**ACUTE
ENGINEERING INC.**

Engineering Addendum

Project Name: Javiena Group Fremont St Remodel (Portland) 2810523
Project Location: 5935 NE Fremont St
 Portland, Oregon 97213
Project Number: 2810523
Date: 5/10/2023

2nd FLOOR FRAMING PLAN

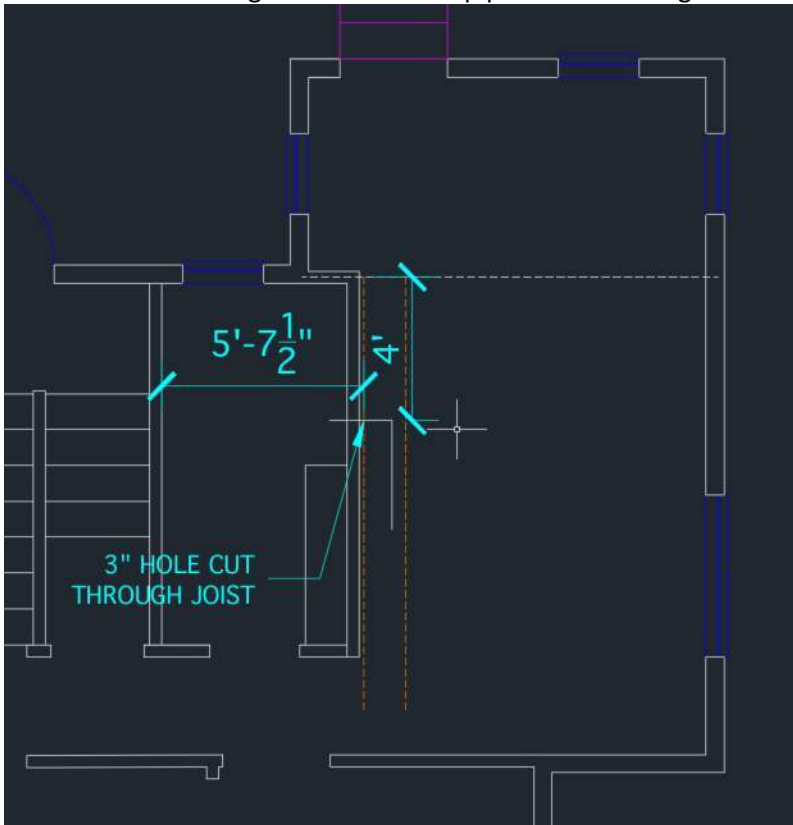
It was requested to verify the strength of a glulam beam that will replace the previous bearing wall.

Mark = RB 01
 Section = 3-1/2 X 12 GLB [24F-1.8E]
 Span = 11.33 ft
 Result = Section adequate by 23 % - Load Combo. No.4 DL + 0.75*(FLL + RLL) - Flexure

BEAM SCHEDULE	
MARK	TYPE
RB 01	3-1/2 X 12 GLB
1. DIMENSIONAL LUMBER DF #2 U.N.O.	
2. LAMINATED VENEER LUMBER (LVL) 2.0E	
3. GLUED-LAMINATED TIMBER (GLB) 24F-1.8E	
4. STEEL W-SHAPES A992-50	
5. SUFFIXES (A, B, ETC.) DENOTE ALTERNATIVES FOR THE SPECIFIED BEAM	
6. ALL HEADERS IN BEARING WALLS TO HAVE MIN. (1) TRIMMER & (1) KING STUD U.N.O. ALL OTHER BEAMS AND GIRDER TRUSSES TO HAVE MIN. (2) 2X SUPPORTS U.N.O.

Left: (2) 2 X 4 (1) K 6314 lb
 Right: (2) 2 X 4 4980 lb

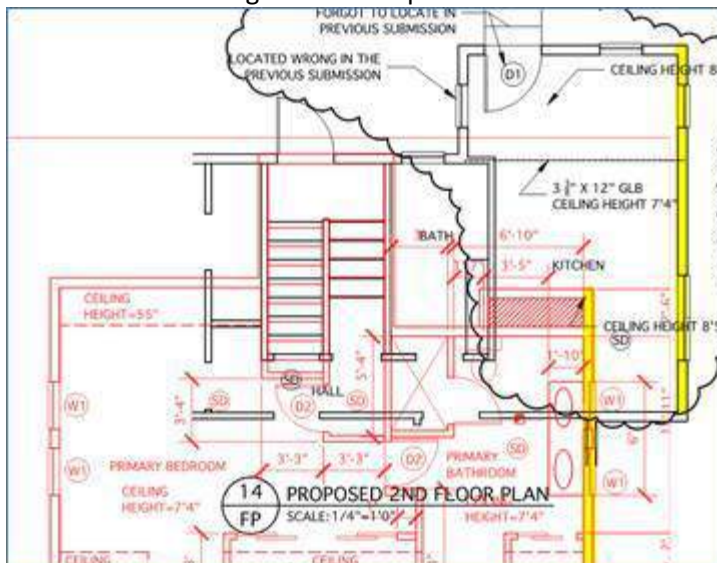
- Clarification on the plumbing hole situation.
 - Where is this plumbing hole on the plans? Is this the upper floor framing?
 - Where is the plumbing hole in relation to its bearing? (e.g. Is it 3'-6" away from a bearing wall?)

- Can you provide pictures of the roof framing up above? I'm trying to determine if this is a floor functioning independently as a floor or if it's part of a roof system.

- Clarification on the right side of the house – When I stack the upper floor (red) on top of the main floor (black), the right sides don't appear to line up. Could you send me some photos from the exterior of the home showing the right side so I can better understand what is happening with these highlighted yellow walls? Since the basement appears to line up with the upper floor, I'm assuming that this popped out kitchen area is sitting on a crawl space extension of the house?

1. Plumbing hole - yes upper floor framing above kitchen
2. Plumbing hole location to load bearing wall - Leo to provide
3. Roof framing pic attached
4. Right side of house - yes popped out and sitting over a crawl space - pic attached
